Troubleshooting Guide

imageRUNNER ADVANCE

C5560 III Series

New Arrival Information

Measures to Prevent Abnormal Noise in the Fixing Assembly

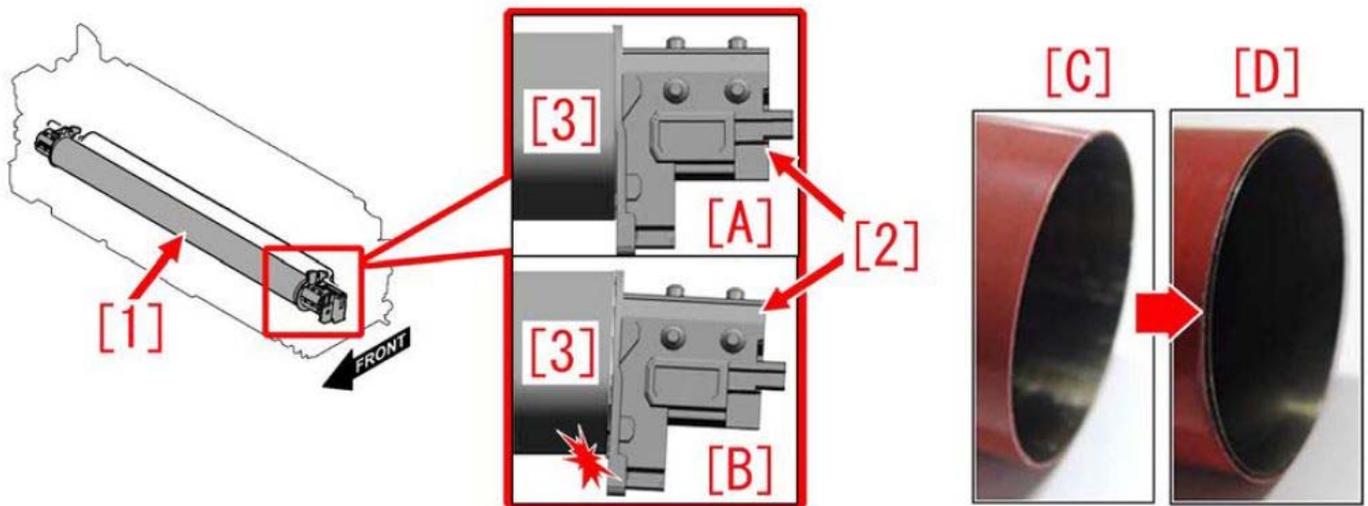
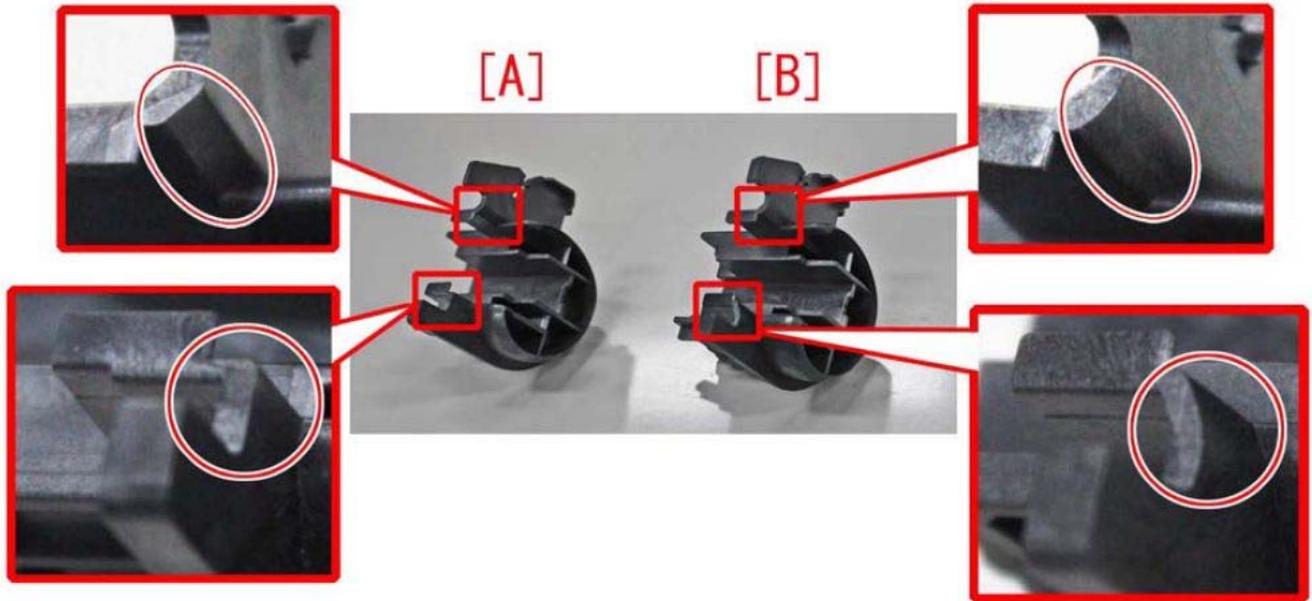
On the film assembly [1], the flange [2] may become slanted [B] if it is pressurized. This pressurization makes the fixing film slanted, causing the flange and the fixing film [3] to become chipped [D]. This results in a noise being produced.

[A] shows the correct position of the flange [2].
[B] shows the incorrect position of the flange [2].

The new type Film Assembly (FM1-N253-010) flange shape has been changed to reduce the chance of chipping.

[A] shows the old type flange.
[B] shows the new type flange.

If this noise continues, prepare a new Film Assembly (FM1-N253-010) to prevent downtime and/or customer dissatisfaction.

Measure to Prevent 010A/020A Jams Due to the 2nd / 3rd Paper Delivery Assembly Reverse Sensor Flag Being Dislodged

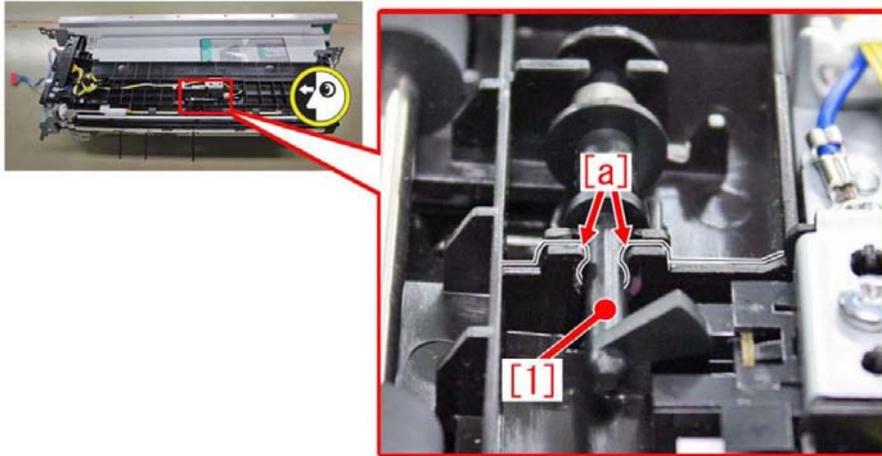
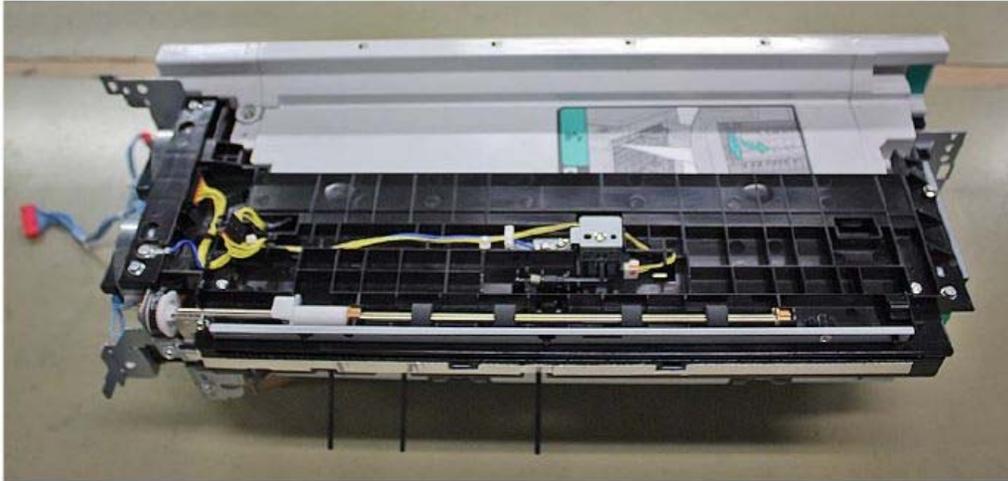
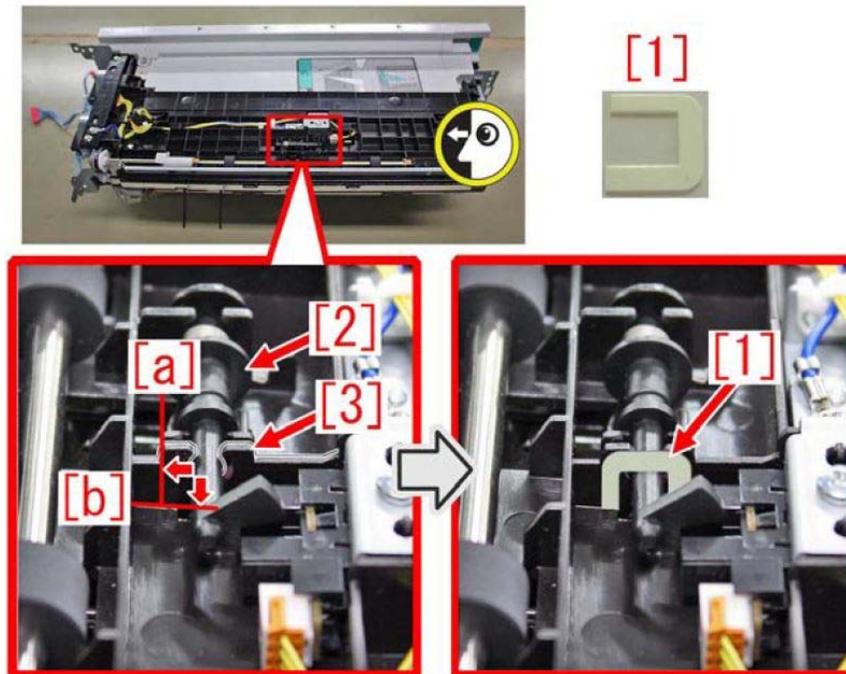
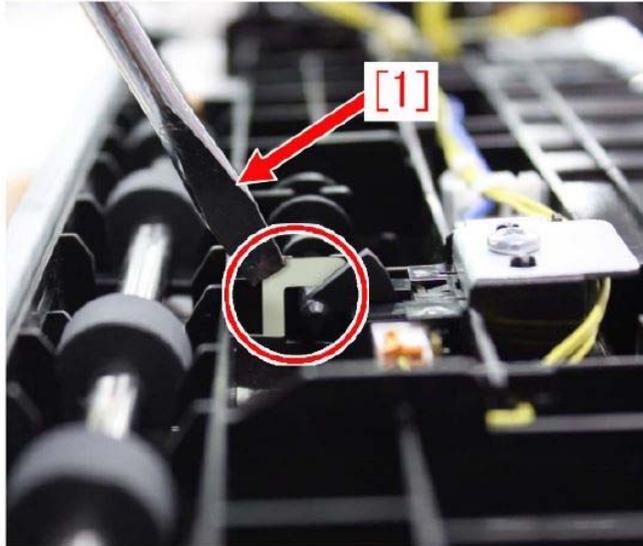
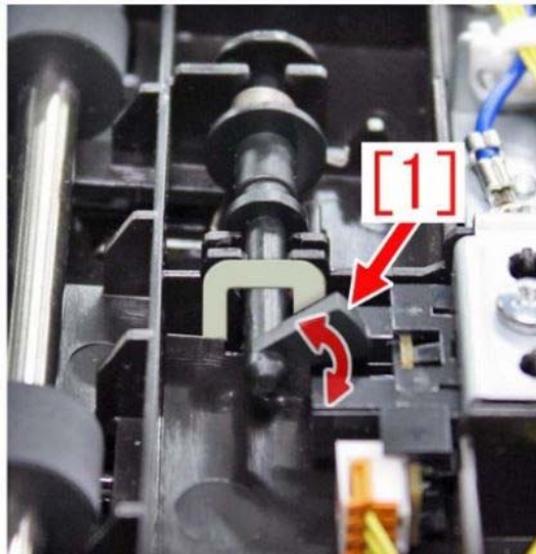
When the overlap amount of the shaft of the reverse sensor flag and the retaining claw [a] of the 2nd / 3rd Paper Delivery up stay is small, the force to retain the reverse sensor flag [1] decreases.

This causes the reverse sensor flag to dislodge when clearing jams in the reversing area.

The result is 010A/020A jam codes.

When this symptom occurs, prepare the Flag Limit Sheet (FL4-2314-000) to be attached to the 2nd / 3rd Paper Delivery Assembly using the instructions in the **SERVICING PROCEDURE** section.

2. Clean the surface where the flag limit sheet of the 2nd / 3rd paper delivery assembly is attached. Then remove the release paper from the flag limit sheet [1] and attach the sheet to the shaft retainer [3] of the reverse sensor flag [2].

- Use the reference lines [a] and [b] to attach the flag limit sheet.
- Do not go over the reference line [a] of the shaft retainer [3].
- Set the flag limit sheet against the reference line [b] of the shaft retainer [3].

Measure to Prevent Image Streaking on Paper Width of 305mm (12 inches) or Larger

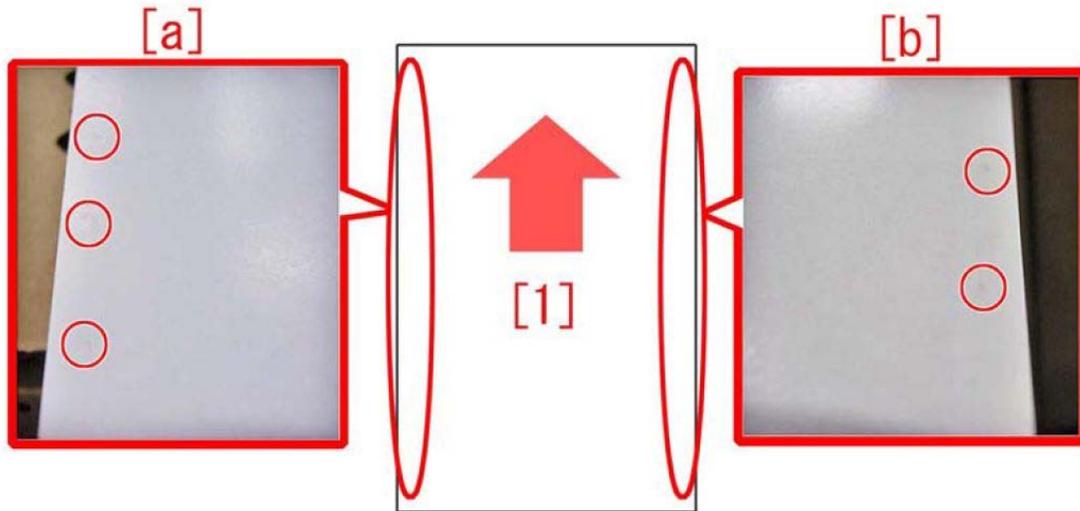
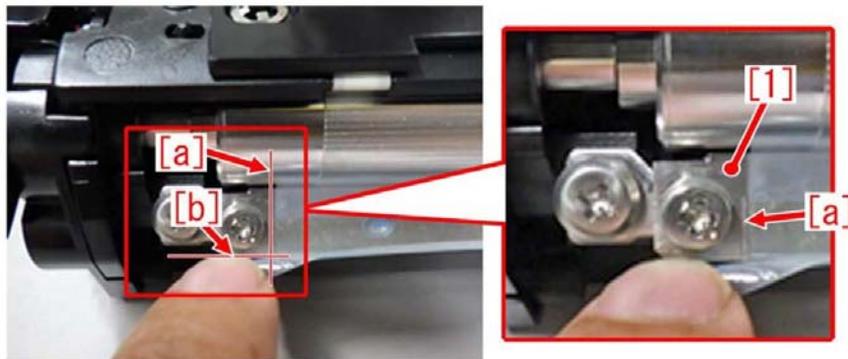
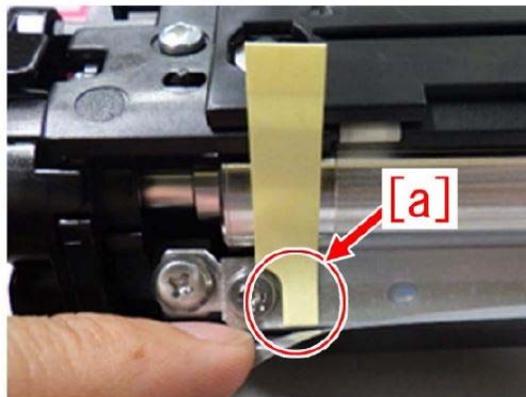
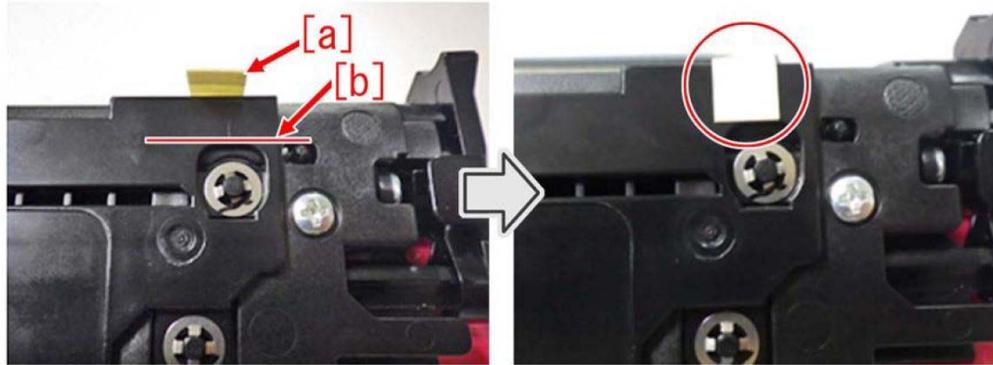
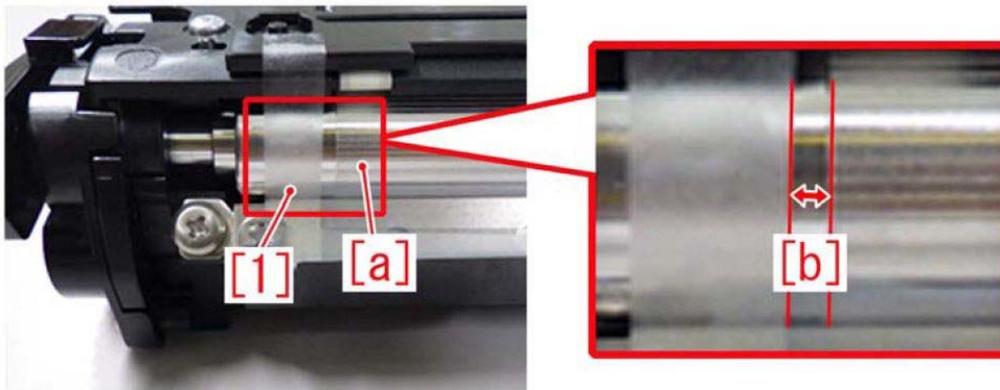
When printing on paper wider than 305mm (12 inches), streaks may occur on the front [a] and rear [b] margins of the paper. For reference, the arrow [1] is the paper feed direction.

This issue is caused by a buildup of developer material on the outer edges of the developer roller. This buildup is what creates the streaks on the front and rear margins of paper wider than 305mm (12 inches).

To prevent this issue from happening, order the newly setup Side End Seal (FL4-1311-000) and follow the procedure in the **SERVICING PROCEDURE** section.

2. Lightly hold down the black and semi-clear sheets outward, located near the blade [1]. Use the marking line [a] on the blade and the bottom edge [b] of the blade as guidelines.

3. Install the Side End Seal (FL4-1311-000) [a] using the blade guidelines mentioned in Step 2.

4. Pull the upper end [a] of the Side End Seal straight up and attach it using the hole located at the top side of the developing assembly as a guideline [b].

6. Ensure the Side End Seal is secure and there is a gap [b] of more than 2mm between the Side End Seal [1] and the coated area [a] of the developing sleeve.

For the Rear Side of the Developing Assembly

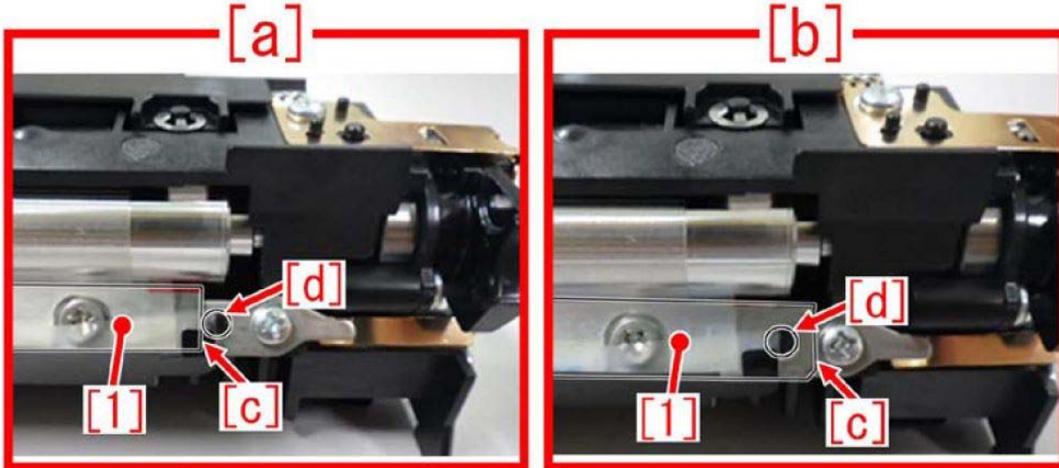
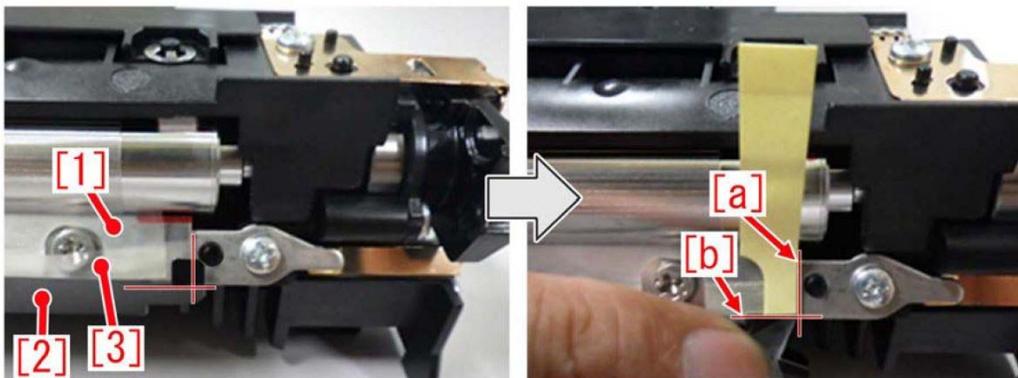
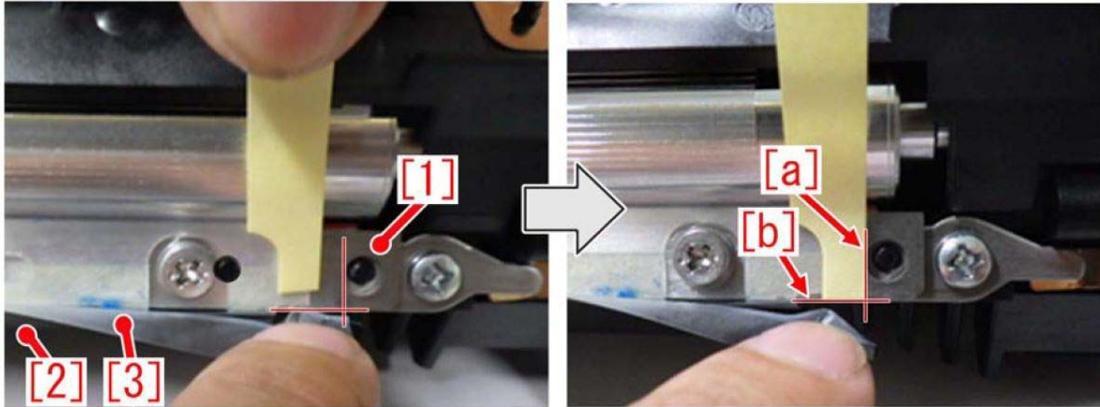
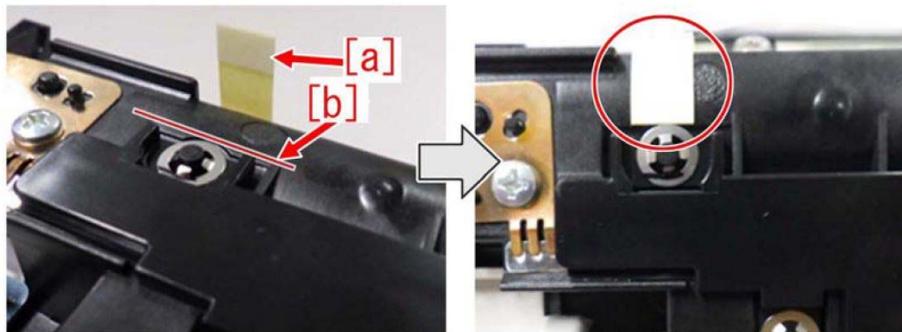
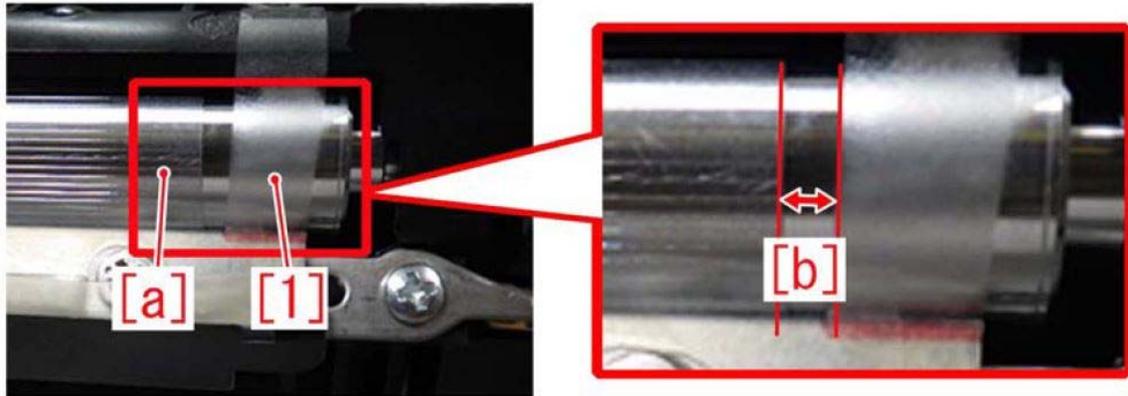
There are two (2) types of developing assemblies (pertaining to the rear side), where the shape of the blade differs on the rear side. Please note the differences below.

If the rear side edge [c] of the blade [1] is located in front of the boss [d], use Type [a] for the first step.

If the rear side edge [c] of the blade [1] is located behind the boss [d], use Type [b] for the first step.

1. For Type [a] developing assemblies, lightly hold down the black [2] and semi-clear [3] sheets outward, located near the blade [1]. Use the rear side edge [a] and the bottom edge [b] of the blade as guidelines. Attach the bottom end of the Side End Seal using those guidelines.

1. For Type [b] developing assemblies, lightly hold down the black [2] and semi-clear [3] sheets outward, located near the blade [1]. Using the front tangent of the hole [a] on the blade and the bottom edge of the blade [b] as a guideline, attach the bottom end of the Side End Seal.

2. Pull the upper edge [a] of the Side End Seal straight up and attach it using the edge of the hole located at the top side of the developing assembly as a guideline [b].

4. Ensure the Side End Seal is secure and there is a gap [b] of more than 2mm between the Side End Seal [1] and the coated area [a] of the developing sleeve.

Points to note when attaching tension spring of the Buffer/Saddle Inlet Flapper(Staple Finisher-V1/V2/Y1/AA1 Booklet Finisher-V1/V2/Y1/AA1)

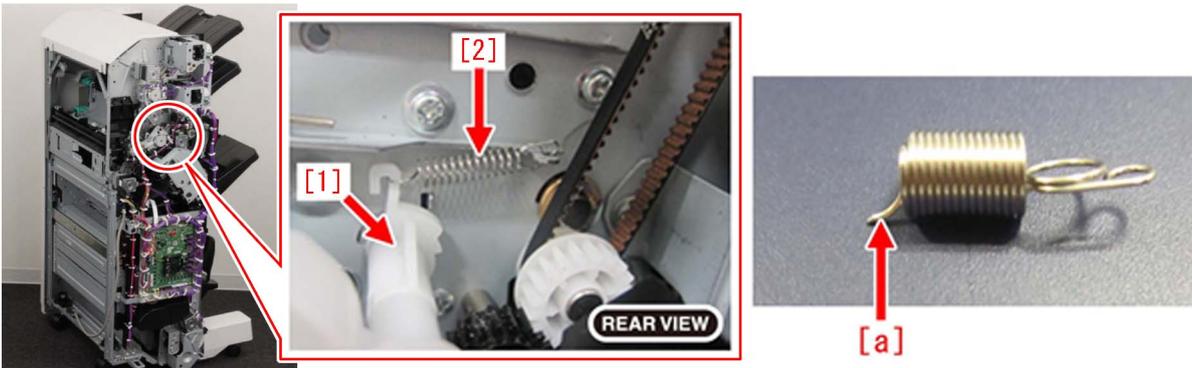
When the tension spring (FE3-8986-000) [2], which has the role to retain the home position of the Buffer/Saddle Inlet Flapper[1] is attached in a twisted condition, it may break [a] during operation. If this tension spring breaks, it may lead to 1002 jam.
- 1002 : Delivery sensor (PS102) delay jam

When attaching the tension spring of the Buffer/Saddle Inlet Flapper, do not twist its hook. Below, photo [A] is showing the normal condition. The spring is attached correctly. Photo [B] is showing the incorrect status.
